Shearon Harris Nuclear Power Plant, Units 2 & 3

COL Application

Technical Specifications

Section A. PSTS and Bases Differences from the DCD GTS and Bases (HAR COL 16.1-1)

FIGURE 4.1-1 Low Population Zone and Site Boundary Map

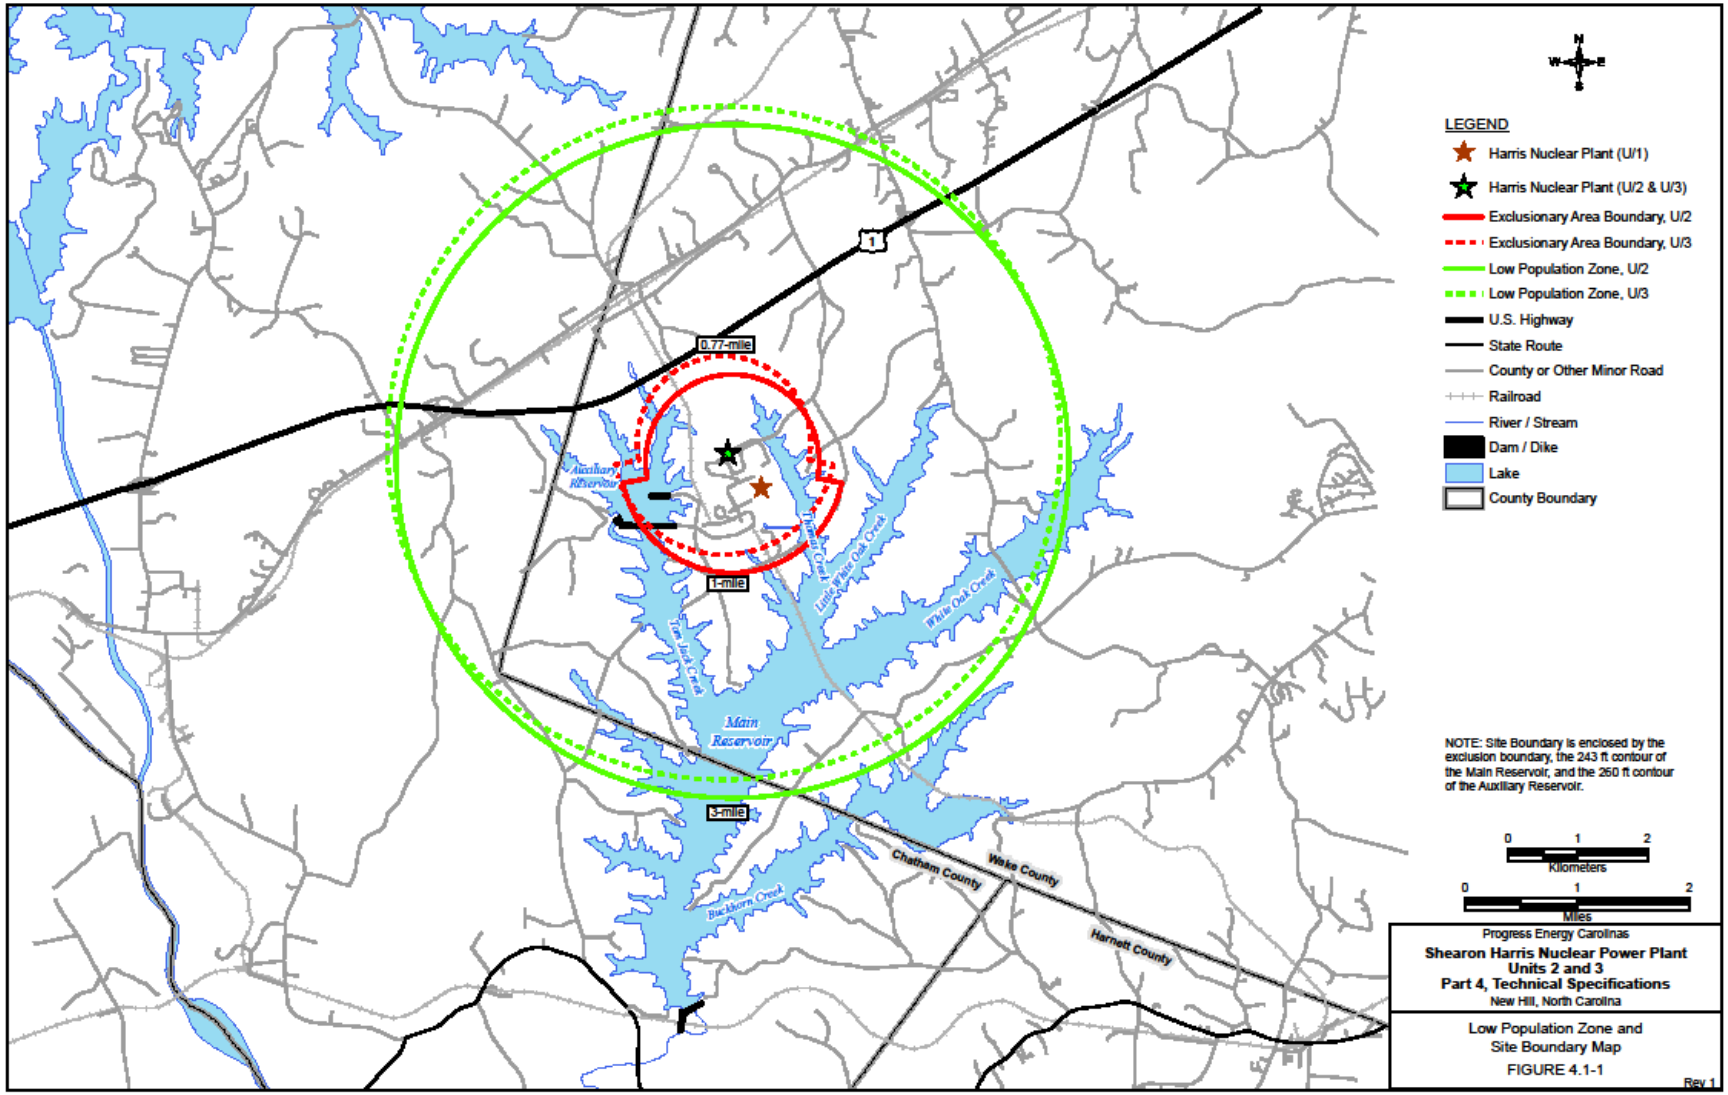
GTS 4.1.1 The bracketed information in the GTS reads:
[This information will be provided by the combined license applicant.]

The Site Boundary is shown in Figure 4.1-1.

Replace the bracketed information in the GTS with the following:
The LPZ is defined by the 3 mile radius from the site center point as shown in Figure 4.1-1.

Replace the bracketed information in the GTS with the following:

Justification
Bracketed information is replaced to establish Site Boundary and Exclusion Area Boundary for HAR consistent with the descriptions identified in FSAR Sections 2.1.1.2 and 2.1.1.3.

FIGURE 4.1-2 Exclusion Area Boundary

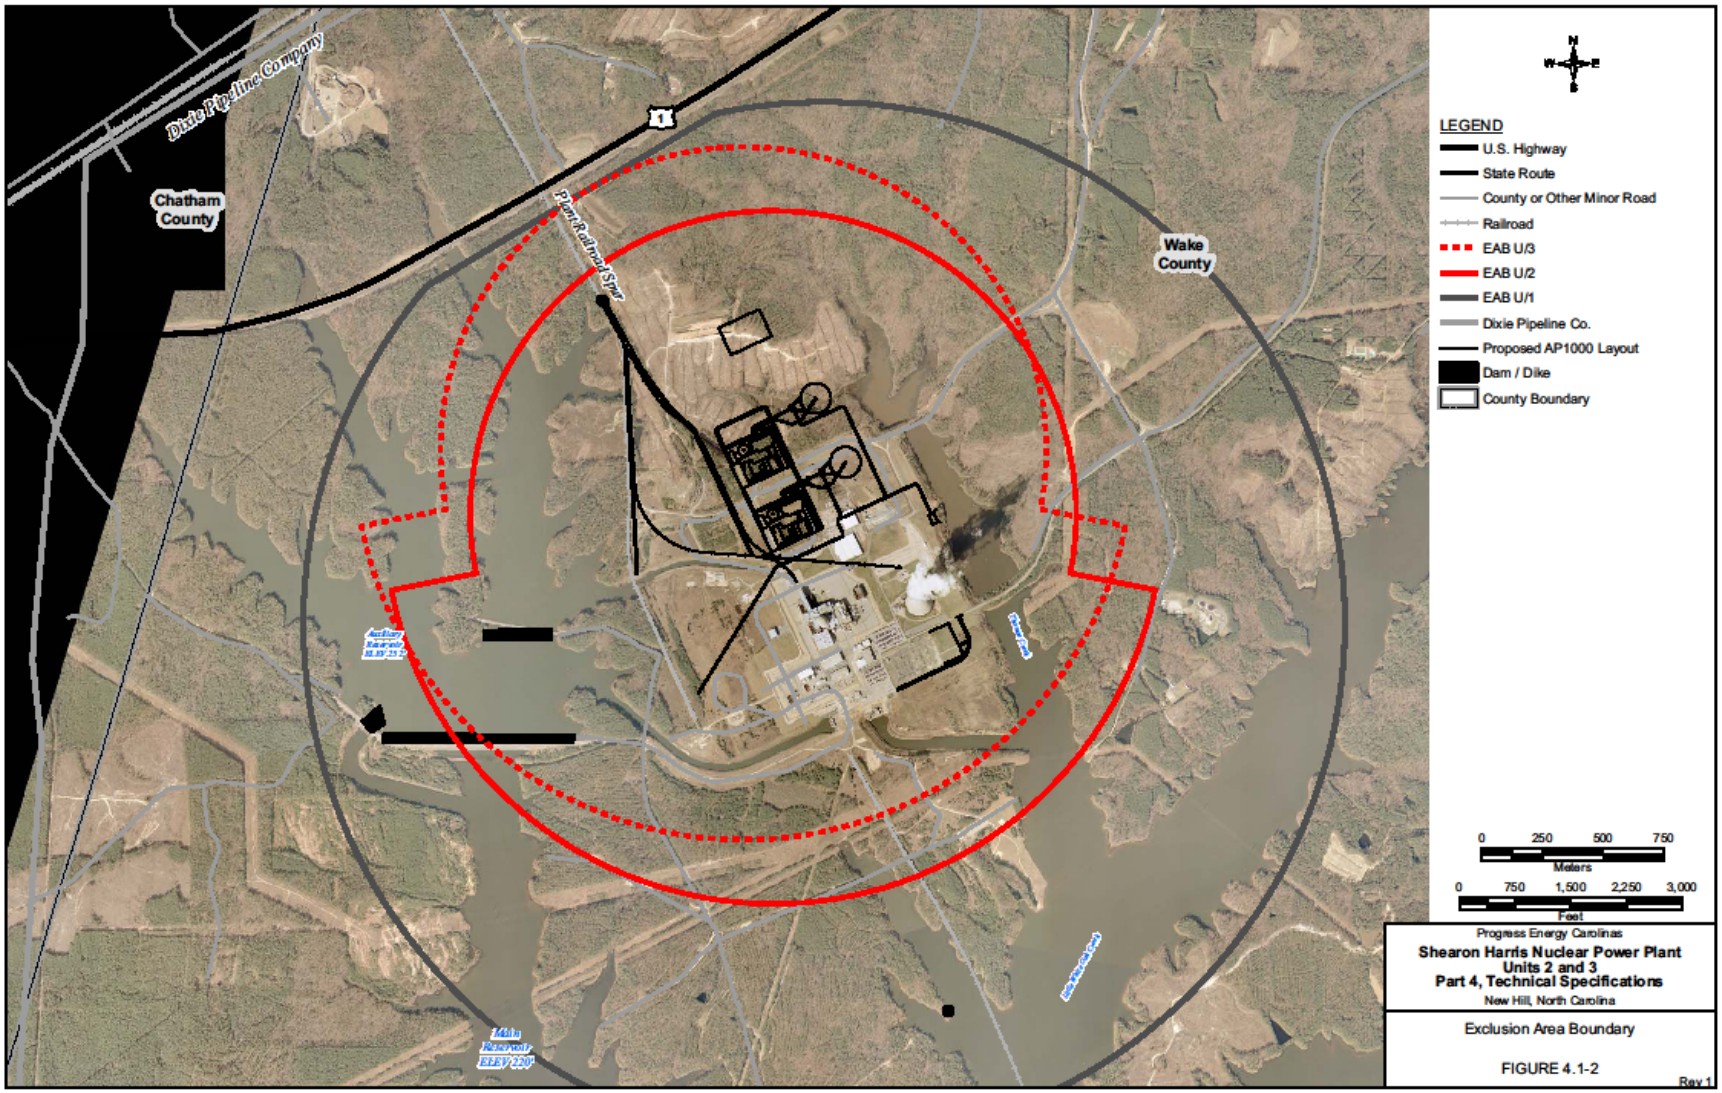
The Exclusion Area Boundary is shown in Figure 4.1-2.
